**RE: Field Issue of embedded holdown device omitted for Lot #6 Cobey creek – 524 SE David Rd.
Lee's Summit, MO 64082 – Permit # PRRES20216072**

FIGURE R602.10.6.2METHOD PFH—PORTAL FRAME WITH HOLD-DOWNS

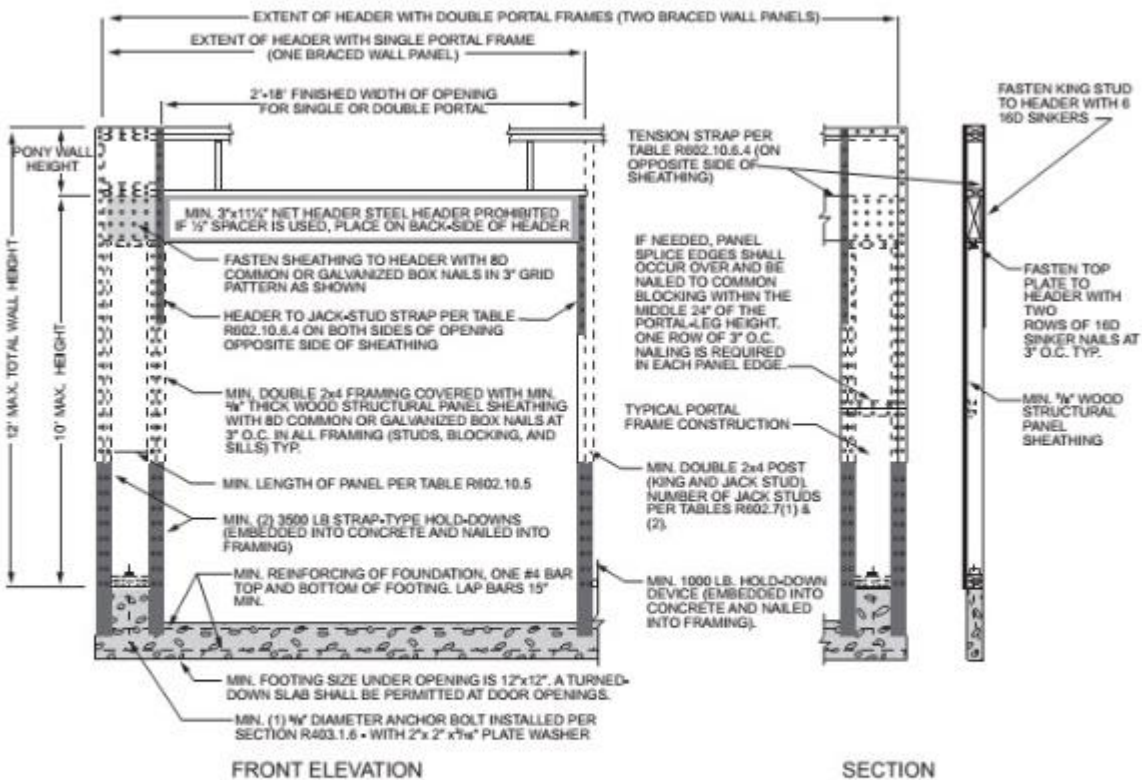
- One 3500# embedded strap holdown was omitted for PFH portal frame at 16' garage door opening:

- Install PFH at garage per IRC figure as shown in image above.
- Install HDU8-SDS2.5 at omitted embedded strap location per manufacturer's spec's.
- HDU8-SDS2.5 shall be drilled and epoxied into foundation wall at 6" depth.
